ENVIRONMENTAL IMPACT REPORT

CARPINTERIA RINCON TRAIL PROJECT
STATE CLEARINGHOUSE NUMBER 2020100582

DECEMBER 2021

Illustration 2-6 Major Storm Drainage Components of the Project

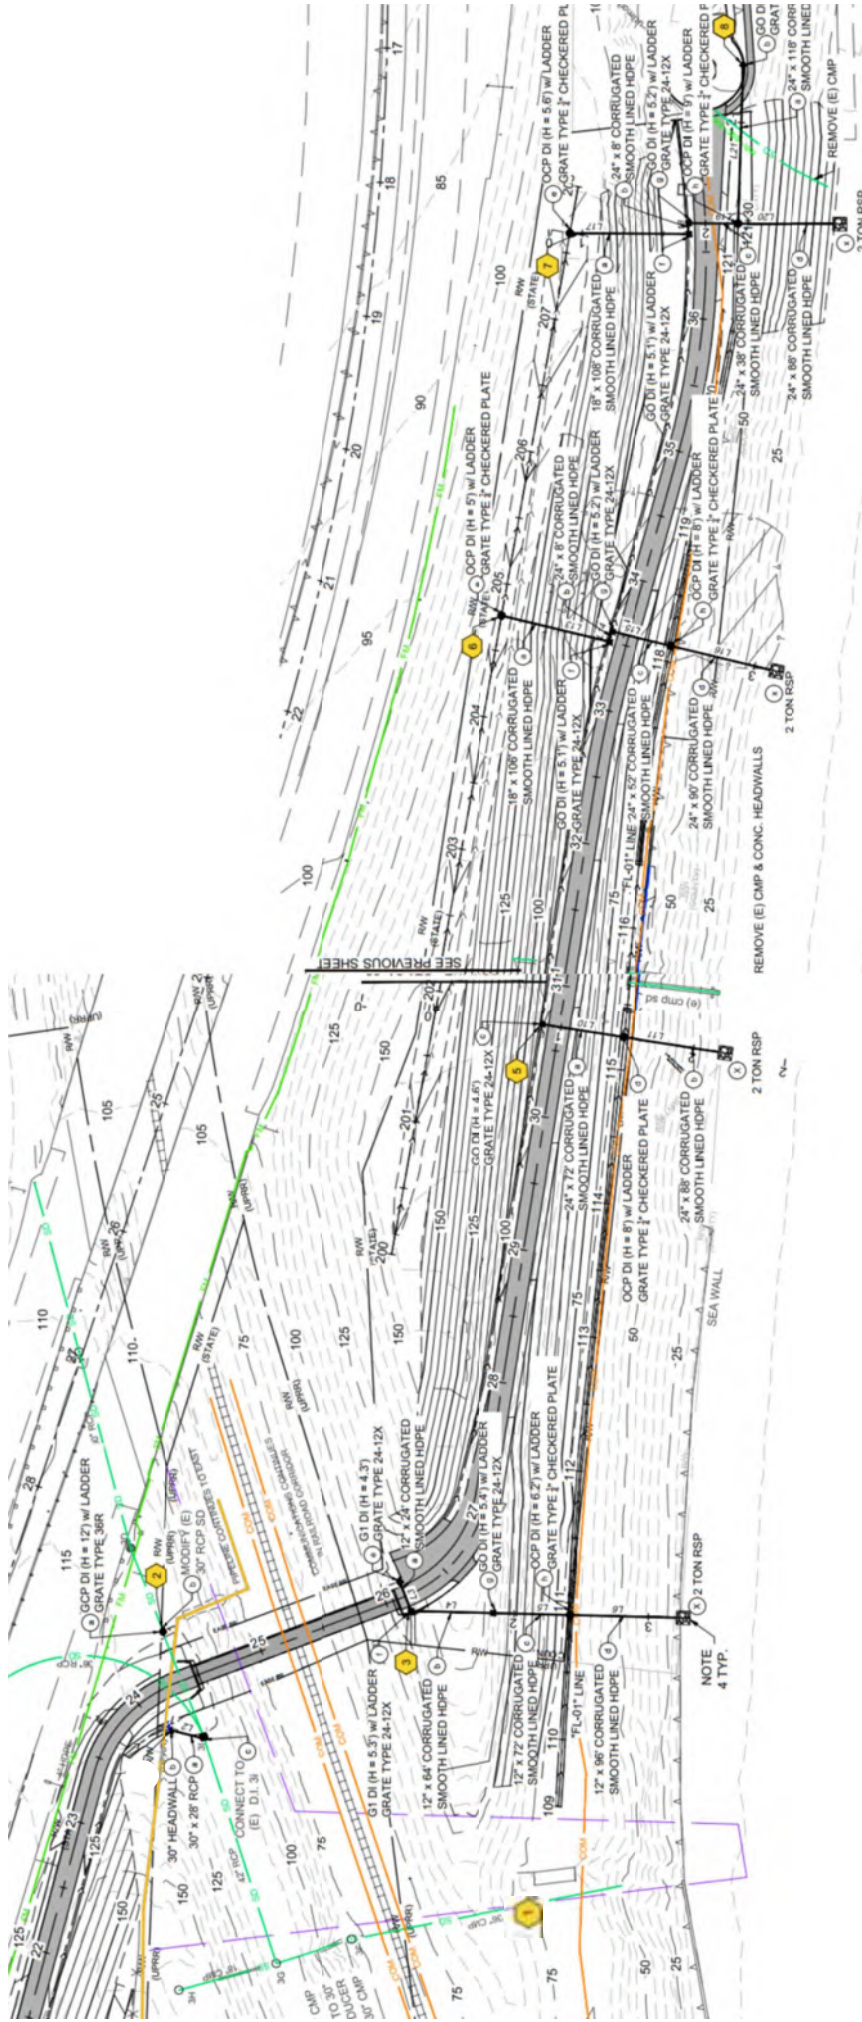
2.7.3 Drainage

The proposed trail project includes an integrated storm drainage system to ensure stormwater runoff from the recontoured bluff face and the trail surface is conveyed to the ocean efficiently, avoiding potential erosion of slopes along the trail alignment. Along the portion of the trail north of the UPRR alignment, a concrete swale (v-ditch) would convey water along the trail edge, where it would be released into an existing surface drainage swale now serving U.S. Highway 101. This swale connects to an existing storm drain that crosses underneath the UPRR alignment, and then descends to the beach level. This storm drain is labelled as “1” in Illustration 2-6. No improvements are proposed to storm drain 1, and the trail storm drain volumes contributed to this storm drain would be negligible compared to existing flows already contributed from portions of U.S. Highway 101.

FIGURE 3.3-1
Biological Resources

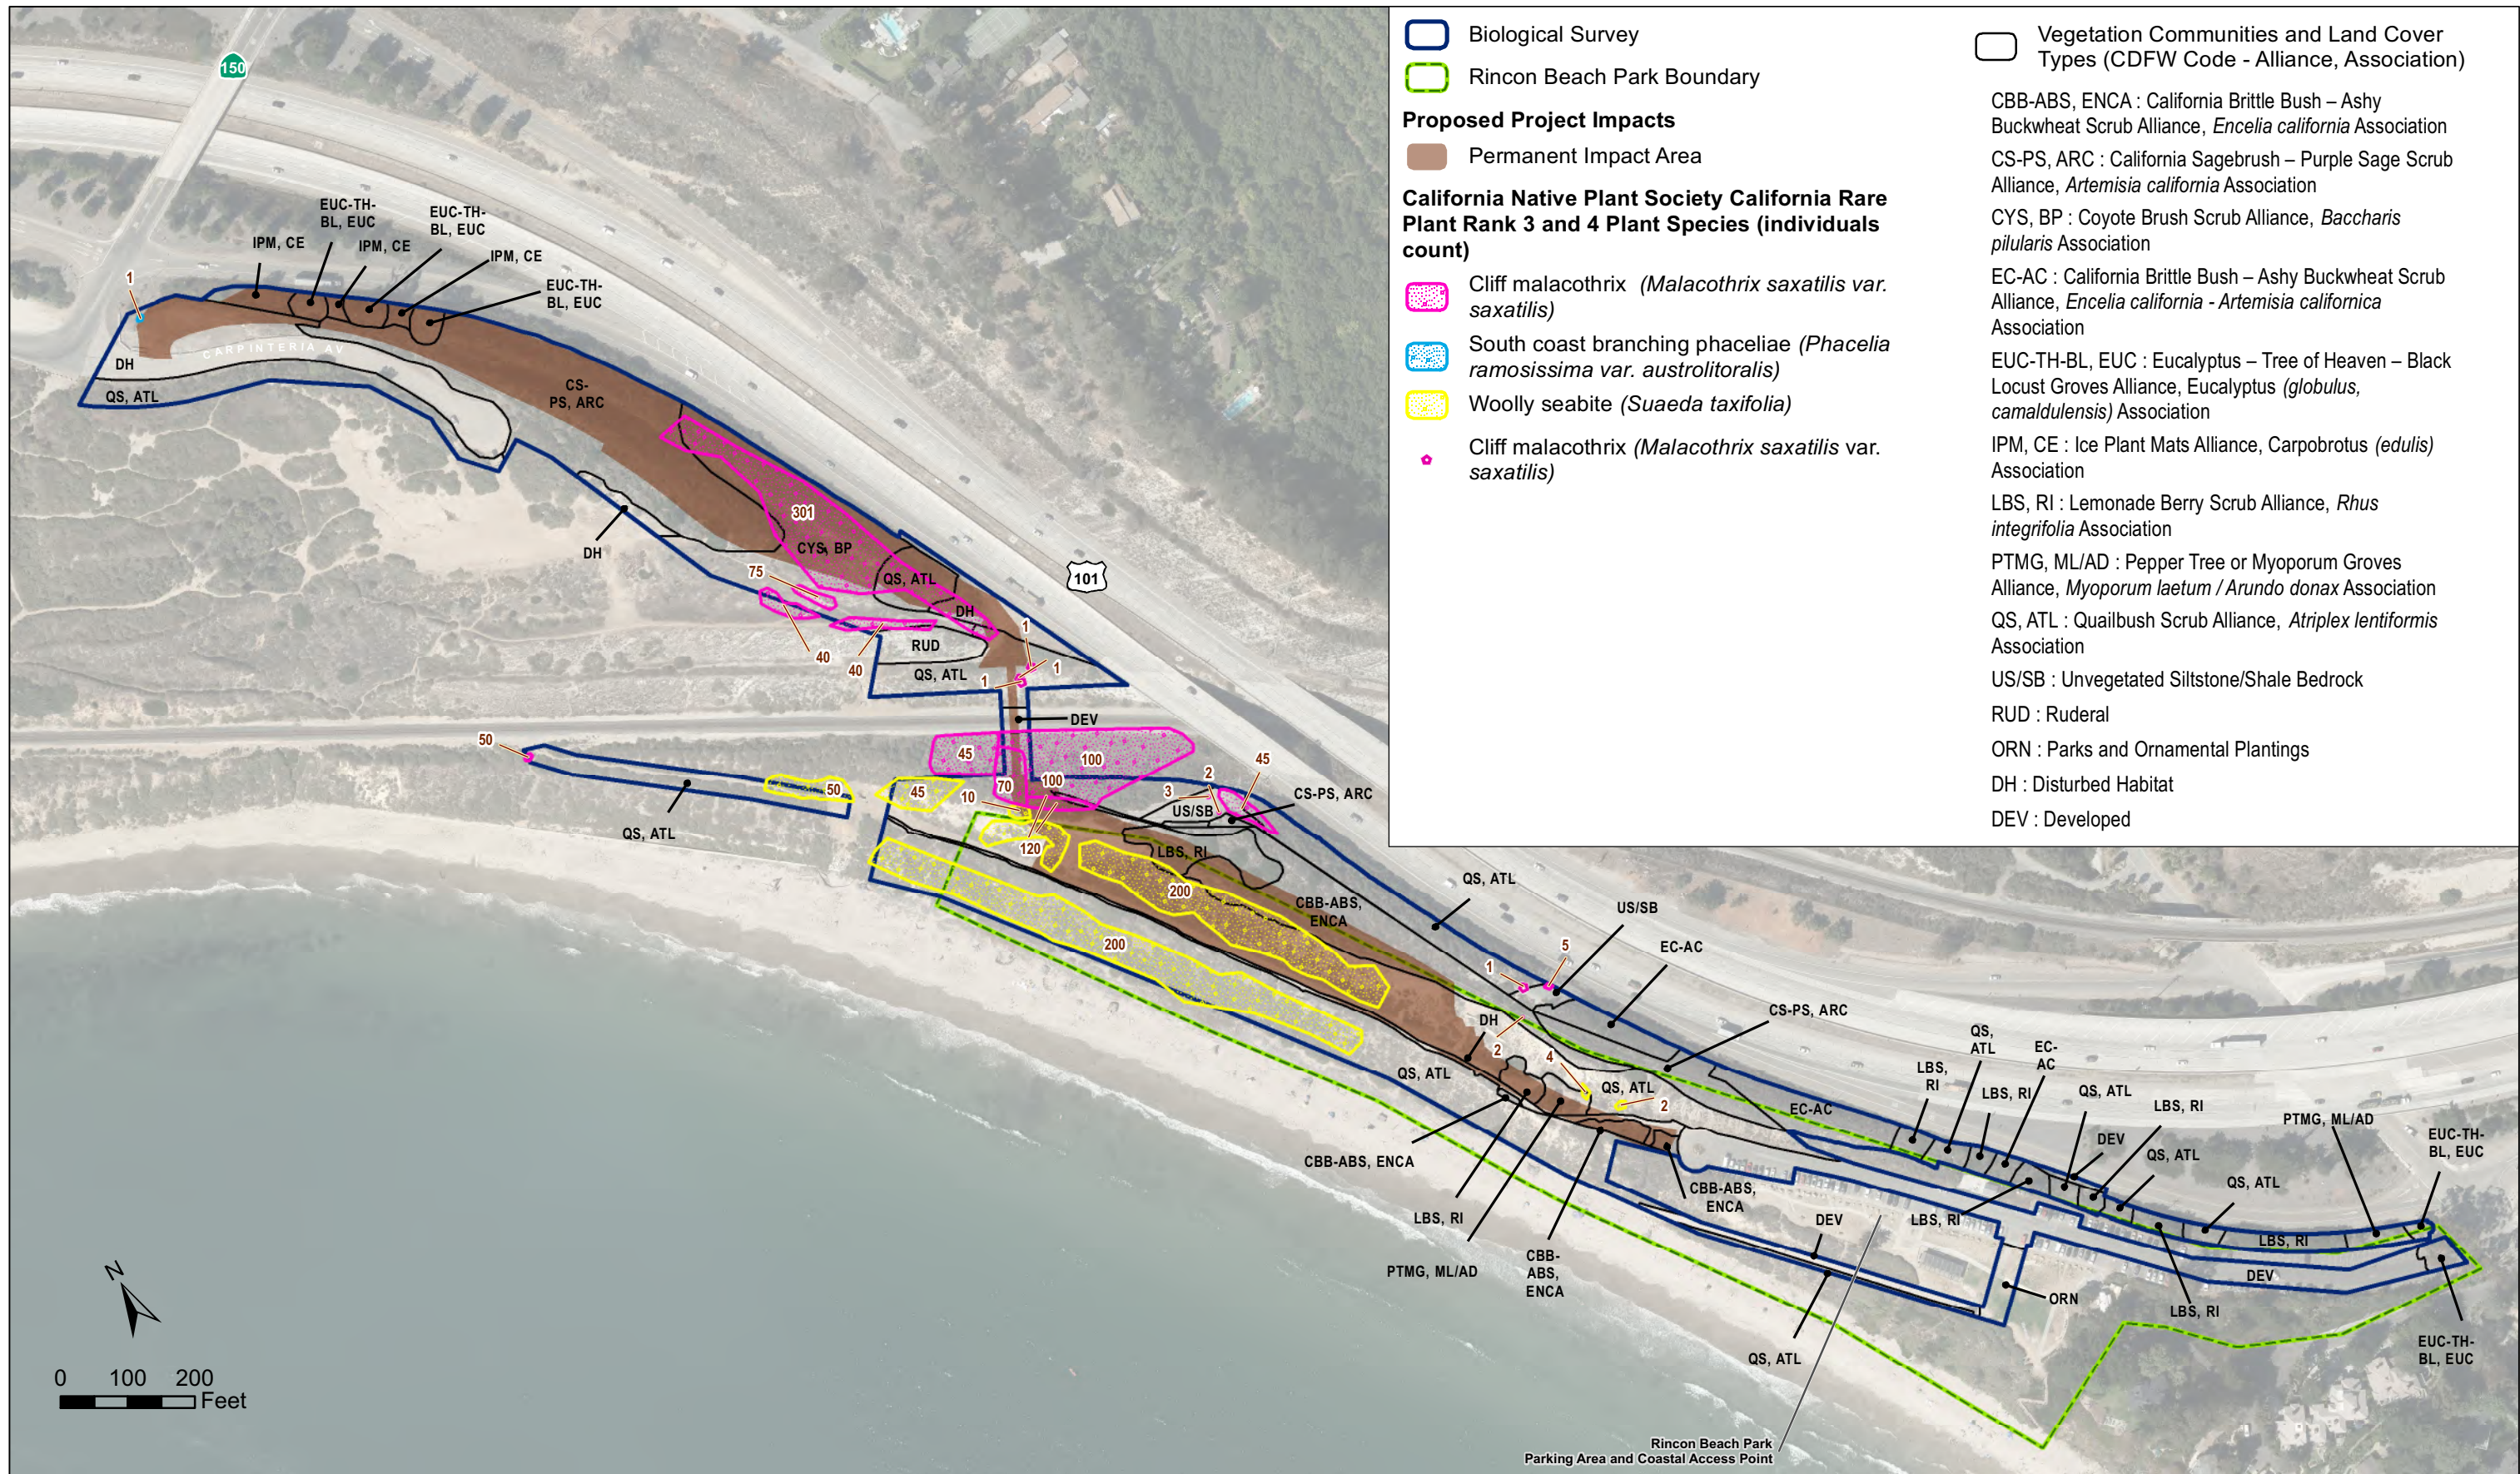
A total of ~~12~~ 14 vegetation communities and land cover types were recorded within the biological survey area, including ~~five~~ six native scrub communities and ~~seven~~ eight non-native communities and land cover types (Figure 3.3-1 and Table 3.3-2). All ~~five~~ six of the native vegetation communities found are protected under the County CLUP (County of Santa Barbara 2019) and the City's General Plan/Local Coastal Land Use Plan (City of Carpinteria 2003), identified as coastal sage scrub, coastal bluff scrub, and/or habitat for sensitive species, and are thus considered County ESH and City ESHA. ~~Two~~ Three of these ~~five~~ six communities, California brittle bush scrub – ashy buckwheat scrub alliance, Encelia californica association, California brittle bush scrub – ashy buckwheat scrub alliance, Encelia californica – Artemisia californica association, and lemonade berry scrub alliance, are also sensitive by virtue of their state rank. These communities are described in CNCL and MCV2. Eucalyptus, ice plant mats, and myoporum are non-native and do not have a state rank (state not applicable [SNA]). The other ~~four~~ five communities and land cover types are not listed in CNCL or MCV2.

Concept Design Alternative 3

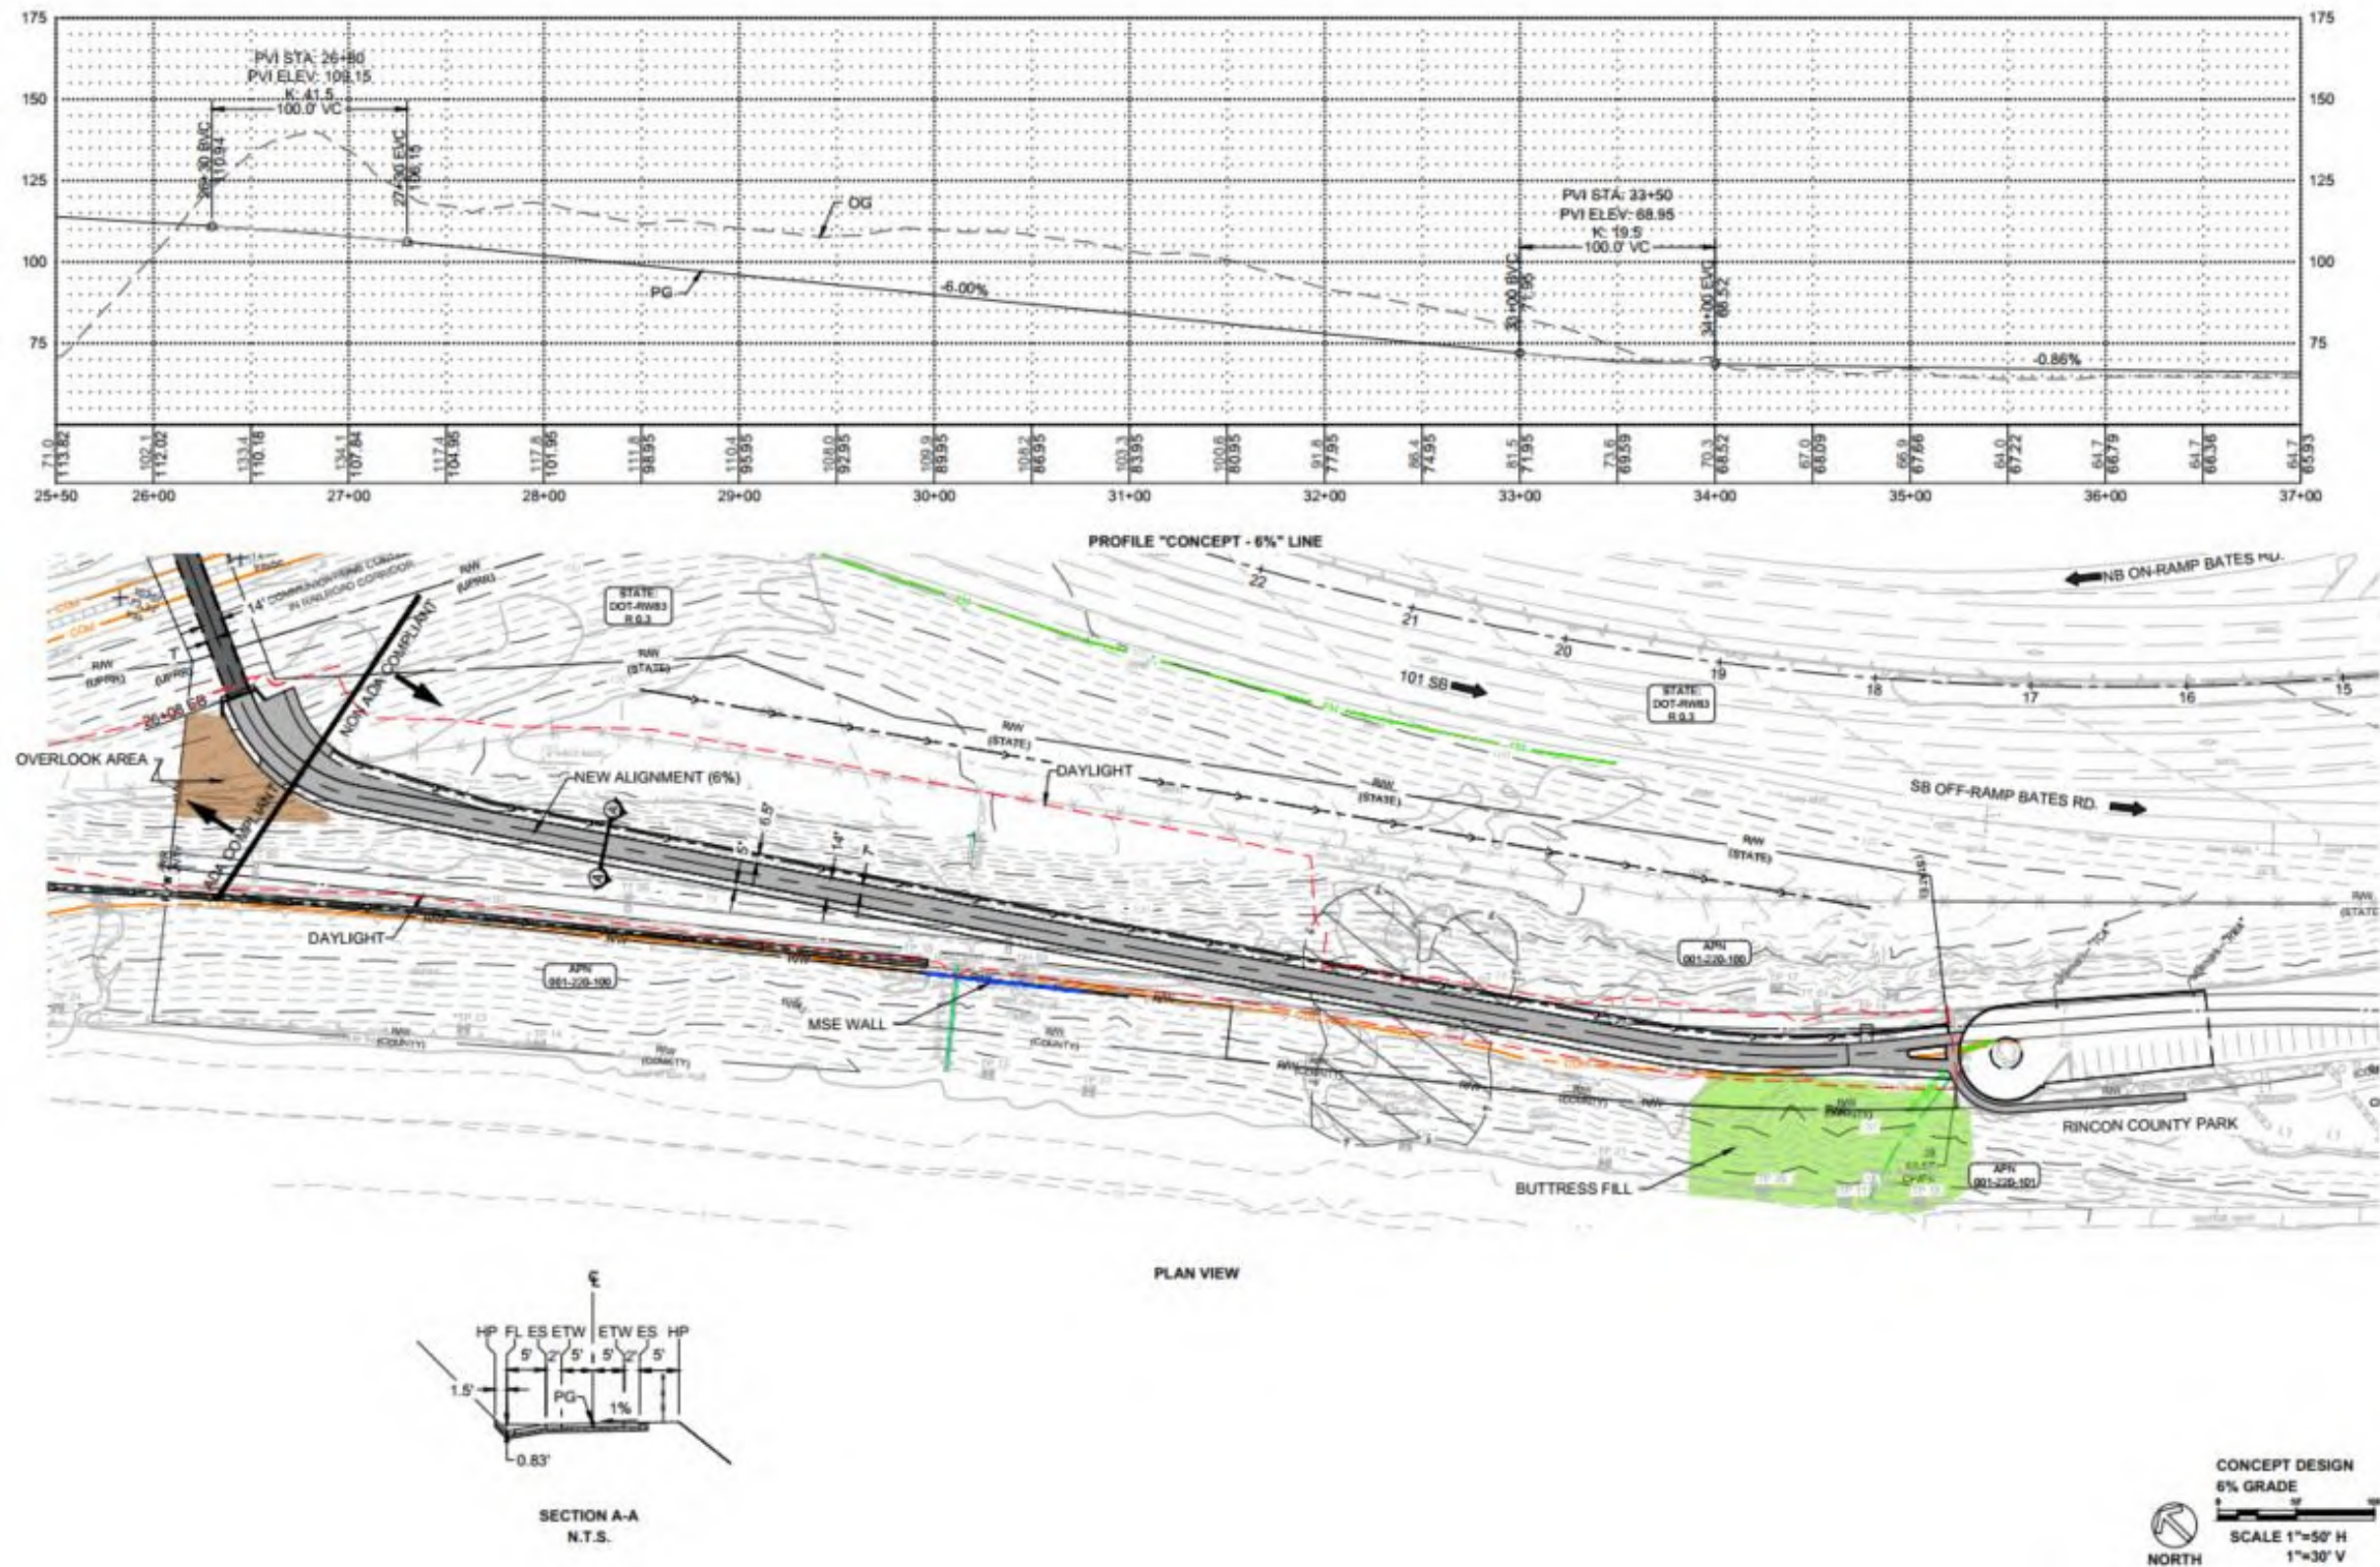
Figure 6-2 (Concept Design 6% Grade) illustrates the alignment of the trail for the segment south of the UPRR crossing under the refined Steeper Slopes/Reduced Earthwork Alternative (Alternative 3). In order to capitalize on the existing historic bench, the trail would need to descend slightly more steeply from the UPRR over-crossing bridge, resulting in a trail segment of approximately 690 feet in length with trail surface slope of 6% as compared to the proposed project that employs a 5% grade along this trail segment. It should be noted that 5% is the maximum trail surface slope for a path/trail to be ADA compliant, and consequently the easterly 690 foot portion of the trail southward of the UPRR crossing would not evidently achieve ADA compliance under the refined Alternative 3. The U.S. Access Board (USAB) is responsible for developing accessibility guidelines for the construction and alteration of facilities covered by the Americans with Disabilities Act (ADA) of 1990 and the Architectural Barriers Act (ABA) of
